**SOLICITATION AMENDMENT  
MODIFICATION DE L'INVITATION**

<b>Title - Sujet</b> CCGC Mechanical and Sprinklers	
<b>Solicitation No. - N° de l'invitation</b> EB144-190543/A	<b>Amendment No. - N° modif.</b> 010
<b>Client Reference No. - N° de référence du client</b> EB144-19-0543	<b>Date</b> 2018-08-16
<b>GETS Reference No. - N° de référence de SEAG</b> PW-\$PWA-121-5750	
<b>File No. - N° de dossier</b> PWA-8-80020 (121)	<b>CCC No./N° CCC - FMS No./N° VME</b>
<b>Solicitation Closes - L'invitation prend fin</b> <b>at - à 02:00 PM</b> <b>on - le 2018-08-21</b>	<b>Time Zone</b> Fuseau horaire Atlantic Daylight Saving Time ADT
<b>F.O.B. - F.A.B.</b> <b>Plant-Usine:</b> <input type="checkbox"/> <b>Destination:</b> <input checked="" type="checkbox"/> <b>Other-Autre:</b> <input type="checkbox"/>	
<b>Address Enquiries to: - Adresser toutes questions à:</b> Russell (PWA), Alex	<b>Buyer Id - Id de l'acheteur</b> pwa121
<b>Telephone No. - N° de téléphone</b> (902) 401-8180 ( )	<b>FAX No. - N° de FAX</b> (902) 496-5016

*This Addendum and all Addenda amends and forms an integral part of the Bidding and Contract documents and shall be read in conjunction with the same.*

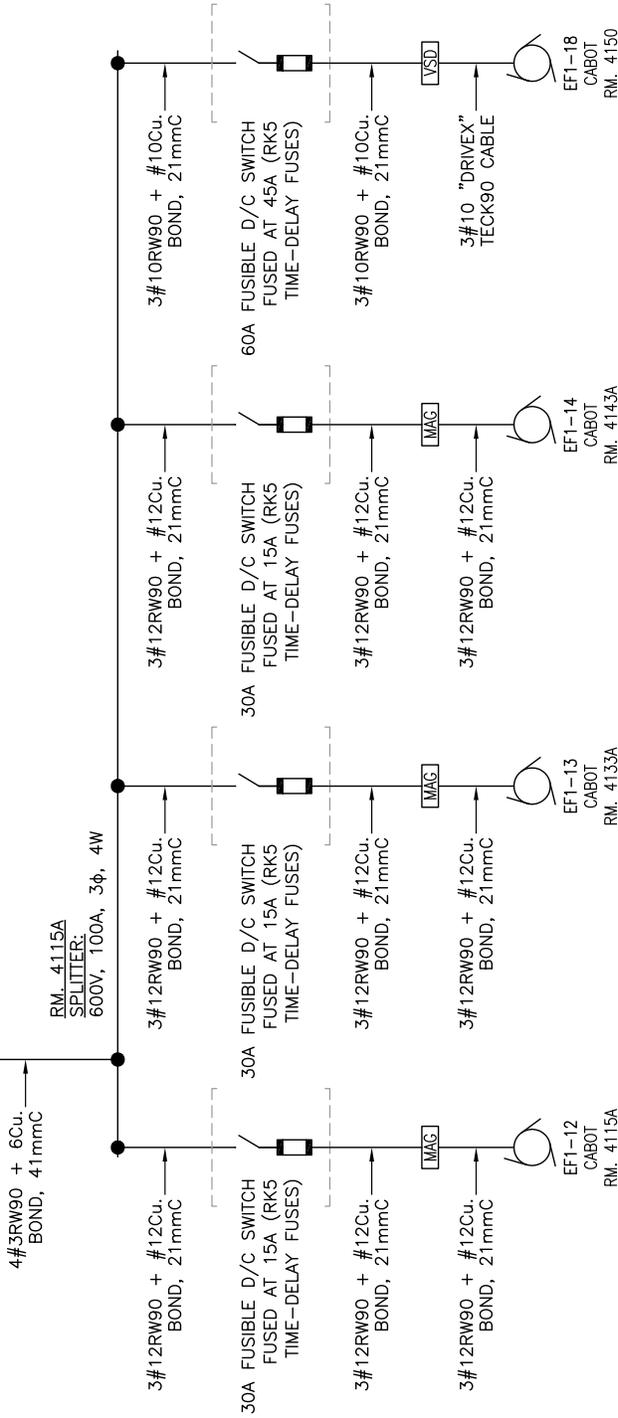
- .1 Revise equipment layout in Boiler Room 1403C, Mechanical Room 1403F and Corridor 1403G as indicated on sketch 01-EP-SK001.

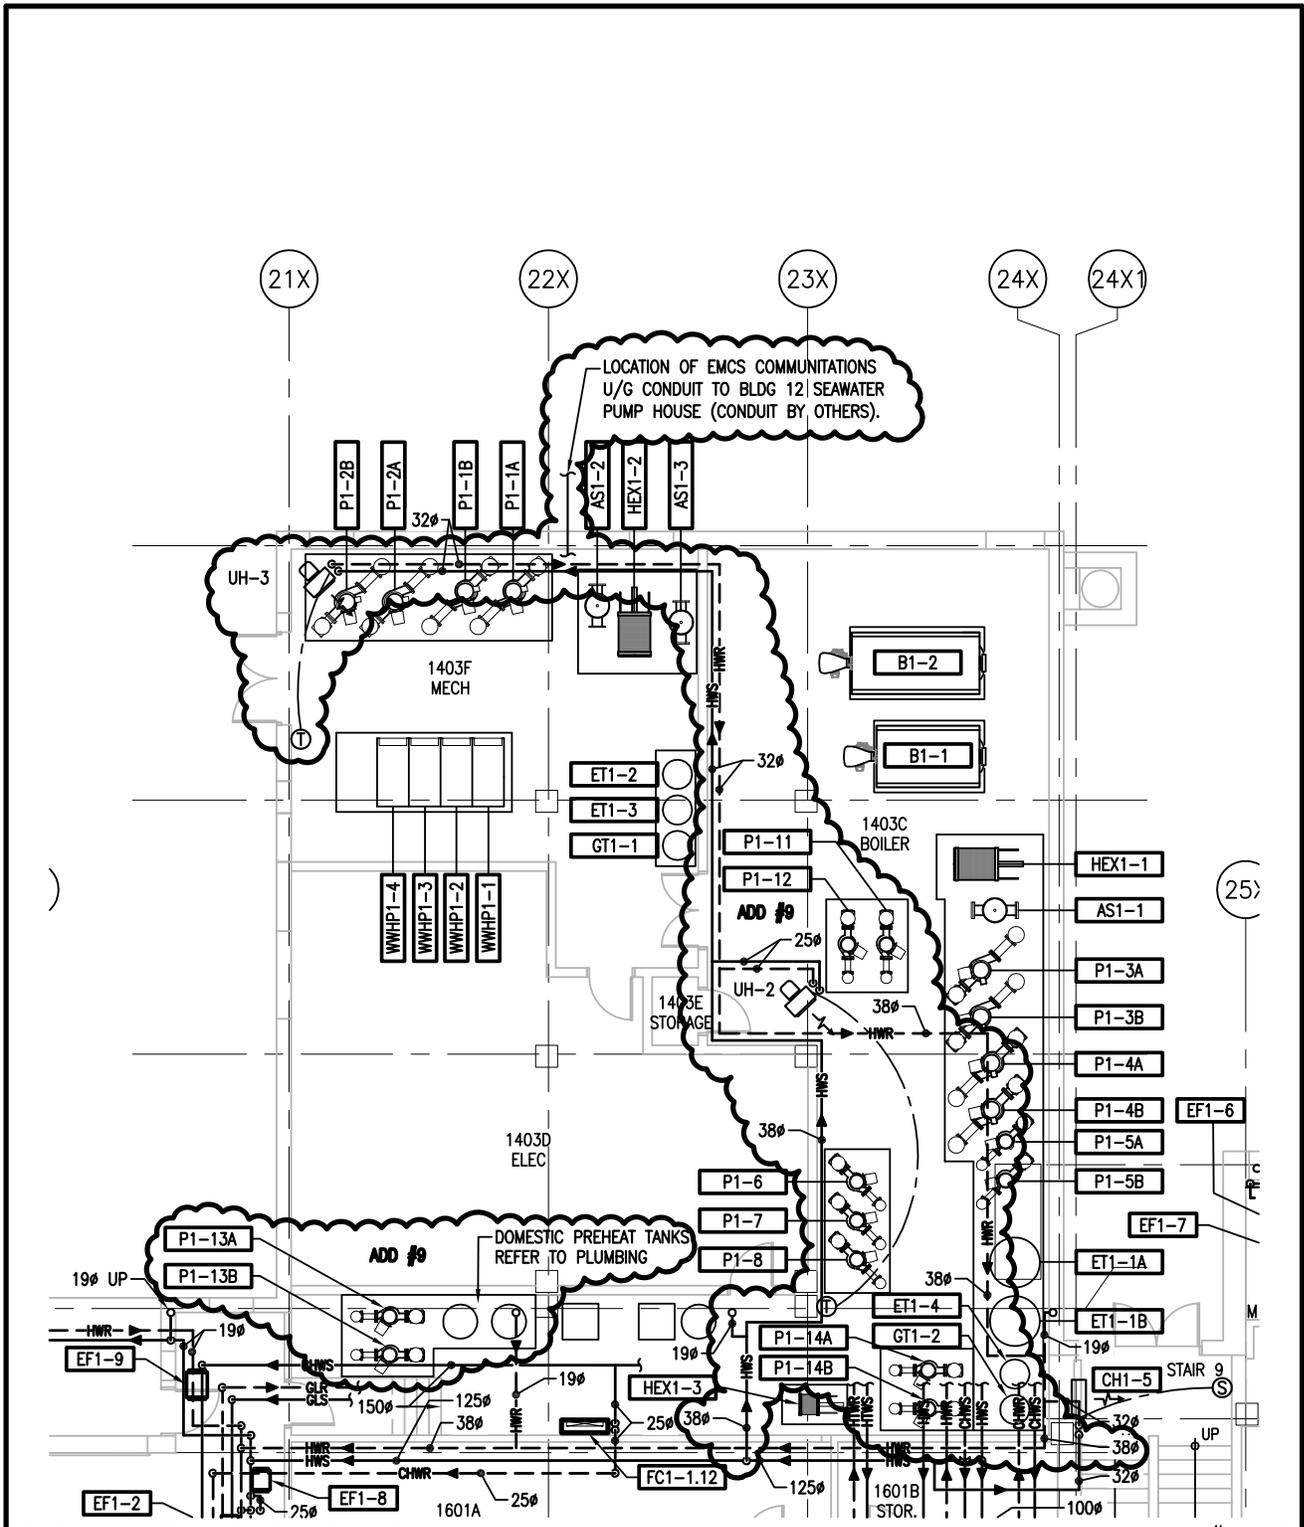
- .1 Revise detail 5 as indicated on 01-E-SK001 (note that EF-14 shall no longer be fed from splitter located in room 4150A).
- .2 Update feeders to equipment shown in single line details as follows:
  - .1 HUM1-2 to be 3#8 AWG + #10Cu. bond, 21mmC.
  - .2 HUM1-7 to be 3#8 AWG + #10Cu. bond, 21mmC.
  - .3 HUM1-8 to be 3#8 AWG + #10Cu. bond, 21mmC.
  - .4 Bond wire in primary feeder serving transformer feeding panelboard PID to be #10.
  - .5 Bond wire in feeder to HUM1-9 to be #10.
  - .6 Bond wire in primary feeder serving transformer feeding panelboard PIE to be #10.
  - .7 Bond wire in feeder to HUM1-4 to be #10.

## 01 - CABOT - LINEAR SLOT DIFFUSER SCHEDULE ADD #9

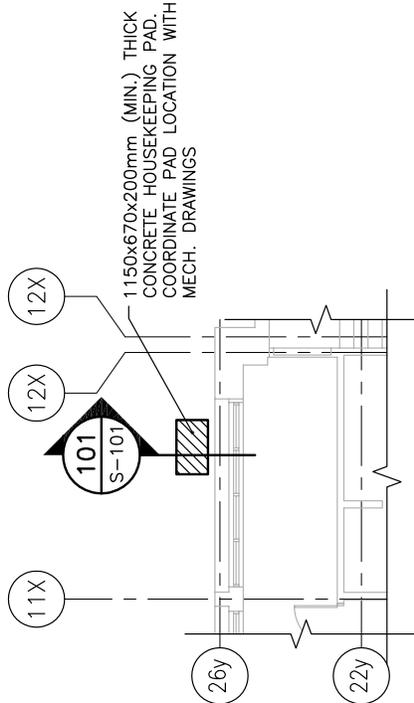
- .1 Add 01- Cabot Ceiling Return / Exhaust Register /Grille Schedule per Sketch 01-MV-SK010 (this Addendum).
- .2 Add 01 – Cabot – Linear Slot Diffuser Schedule per attached Sketch 01-MV-SK011 (this Addendum).

Reference Drawing: 03-MC-102

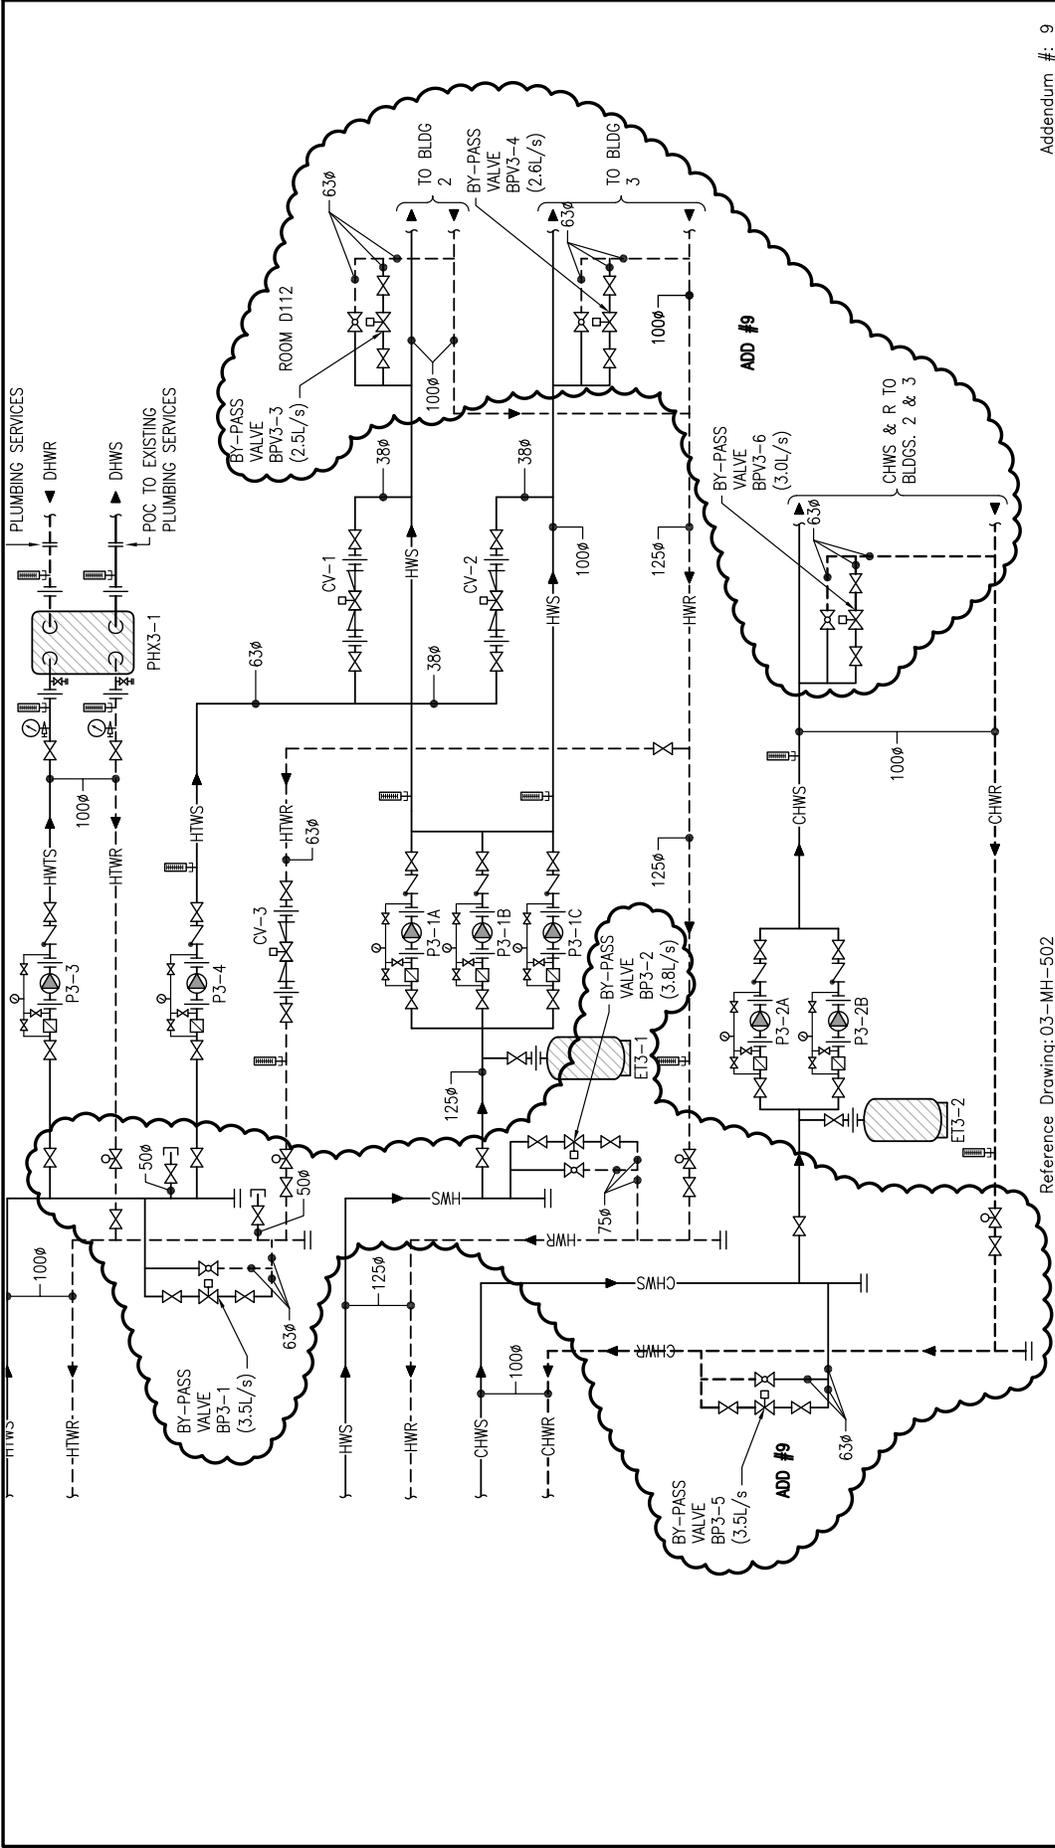
- .1 Detail 1: Revise Hydronics Systems Control Schematic per Sketch 03-MC-SK001 (This Addendum).

## NEW DOOR TYPE:

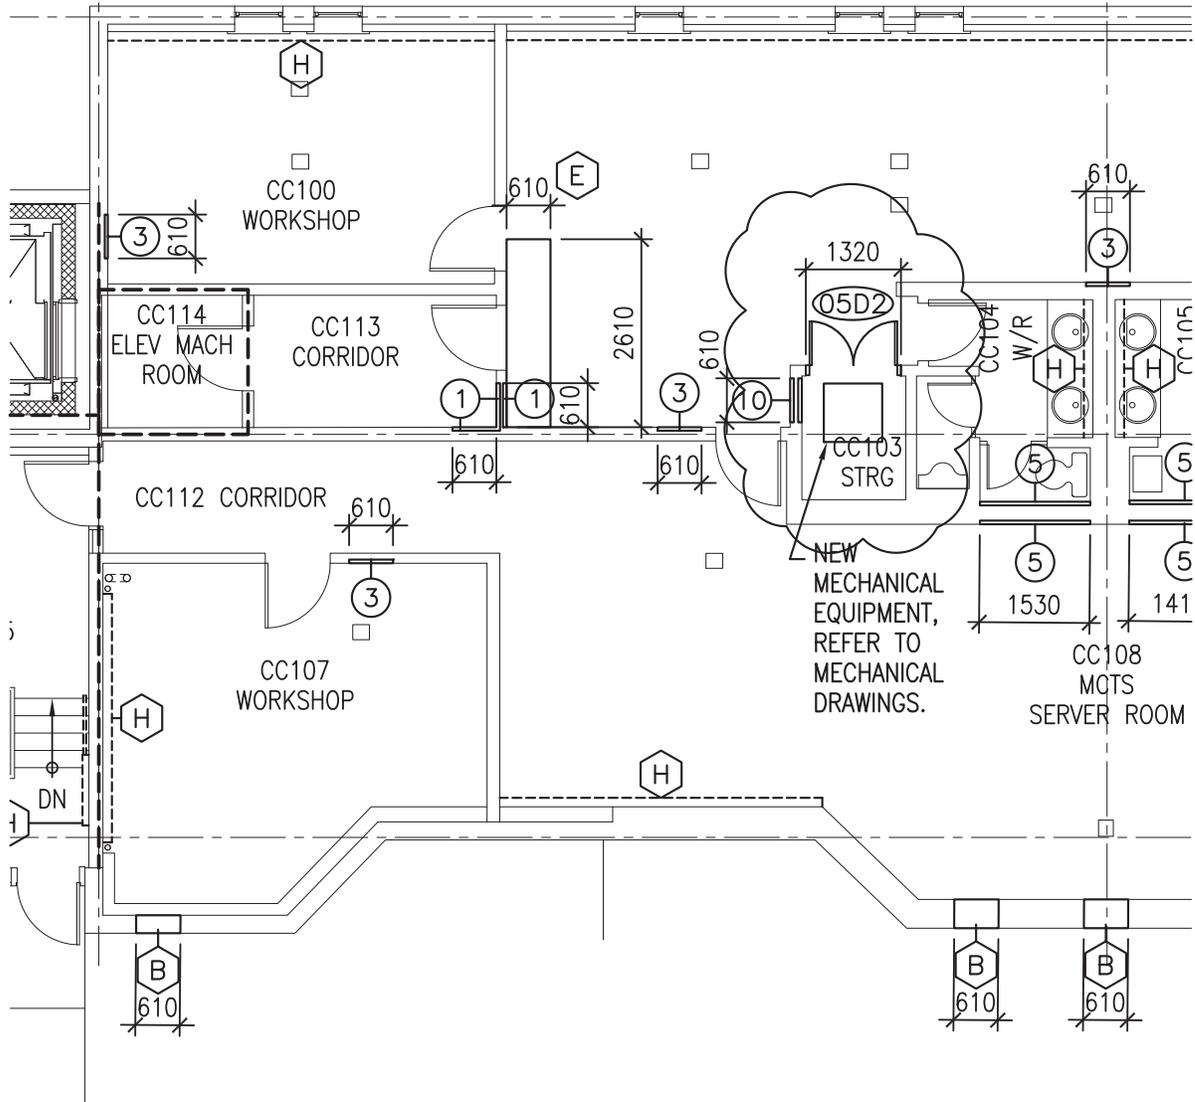
- .1 Add the following:
  - .1 Door D5D2.
    - 2-610 X 2134
    - Insulated Hollow Metal Door.
    - Positive Latch, Deadlock from opening Sideonly.
    - Provide Sweep, Threshold, Steel Astragal and Acoustic Seals to Provide STC45.
    - Frame Filled with Acoustic Batt, Friction Fit Batt to Opening.
  - .2 Partition type 10 at room CC103 STRG including 1320 x 2235mm door opening and header as shown on the drawing. Wall finishes to match adjacent new.

- (05D2) -2 - 610 x 2134
- INSULATED HOLLOW METAL DOOR AND FRAME
- PROVIDE SWEEP AND CLOSER
- THRESHOLD

**HYDRONIC SYSTEMS CONTROLS – MECHANICAL ROOM FF11A**  
 N.T.S.  
2  
MC102

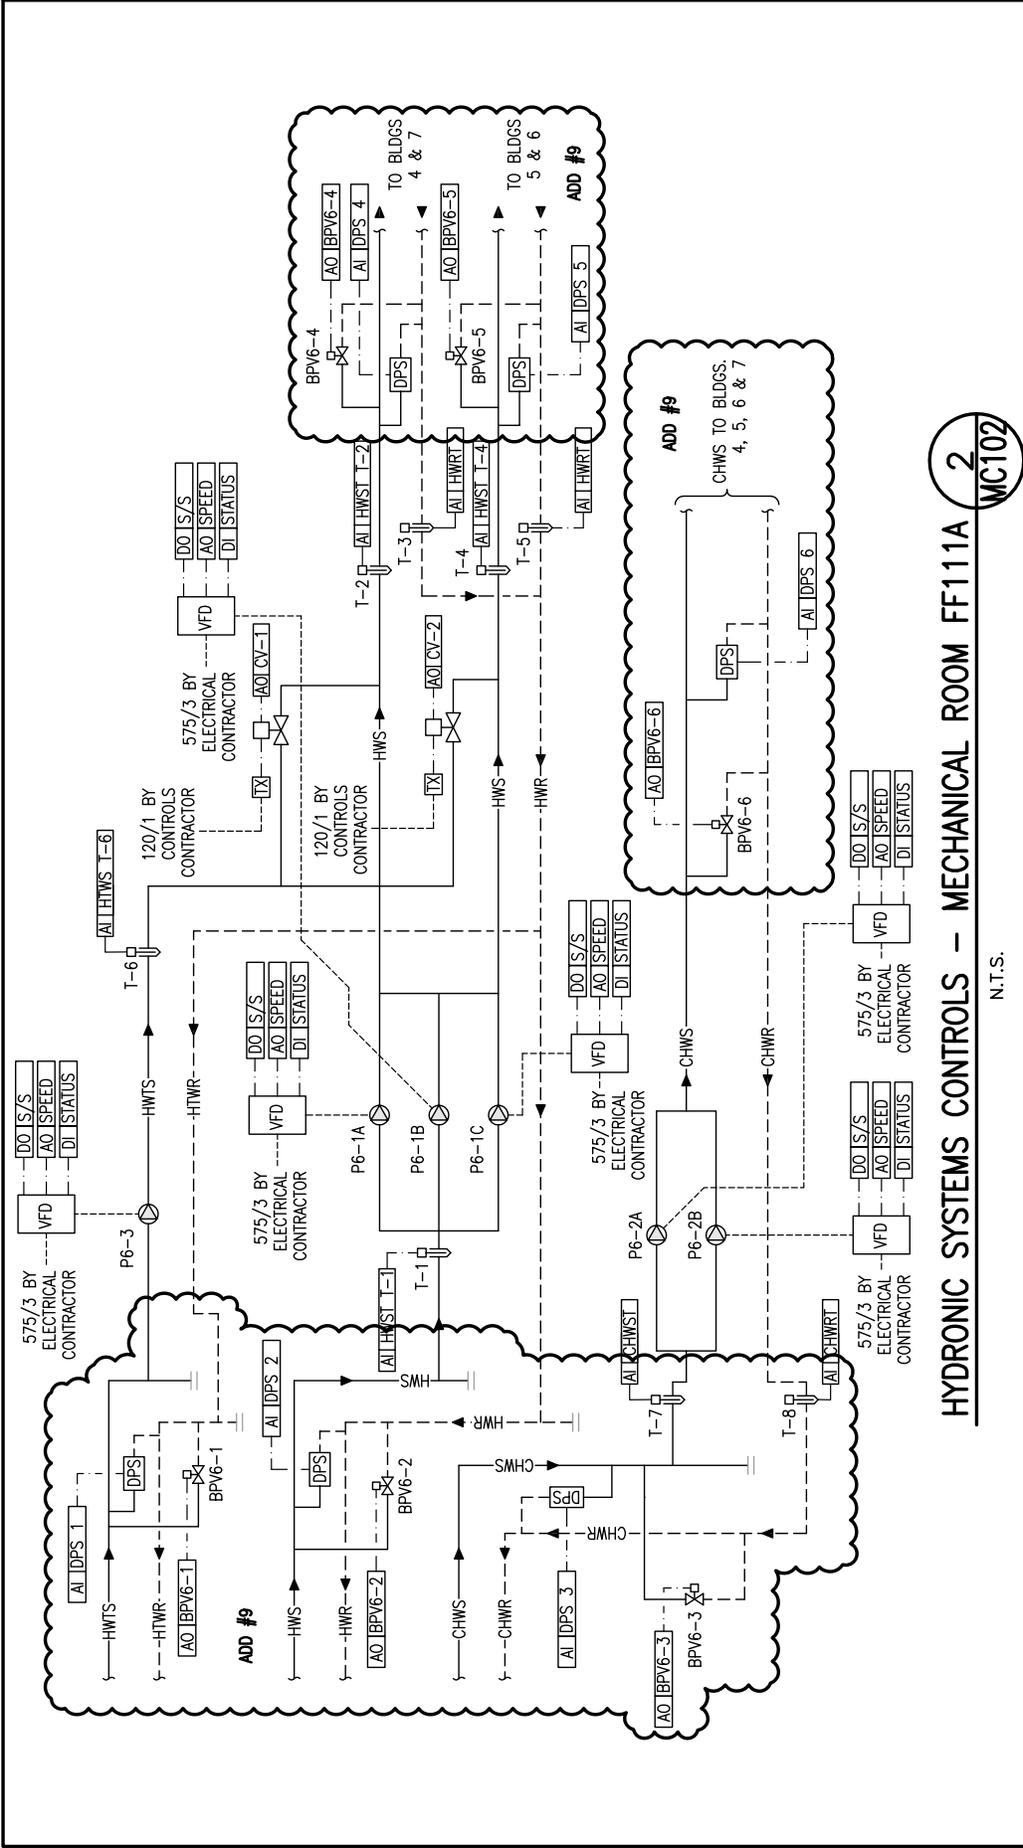
- .1 Detail 2: Revise Hydronics Systems Controls Mech Room FF110 per Sketch 06-MC-SK001 (This Addendum).
